OCTOBER 5, 2026 REGULAR MEETING

De Minimis Waiver No. 26-007 / 29215 Larkspur Lane

Planning Commission Meeting
10-05-26
Item 3.B.1.

NEW POOL ADDITION TO AN EXISTING HOUSE

DATE: 7/23/26
PROJECT No.: 2515
DRAWING BY: NC, DT, KS
DWG No.: A-2.1
SHEET No.: 1

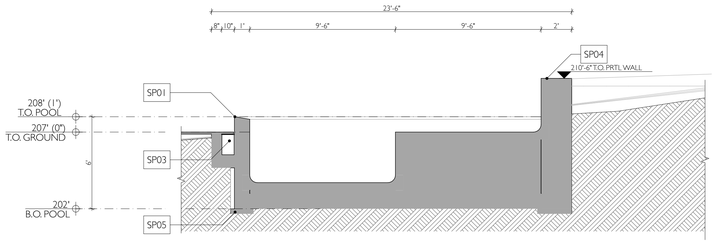
2. Please revise Note D on Sheet A-2.1 to identify the correct foundation system for the pool and the correct Project Geotechnical Engineer and referenced report. Please clarify if there is a spa and where it is located.
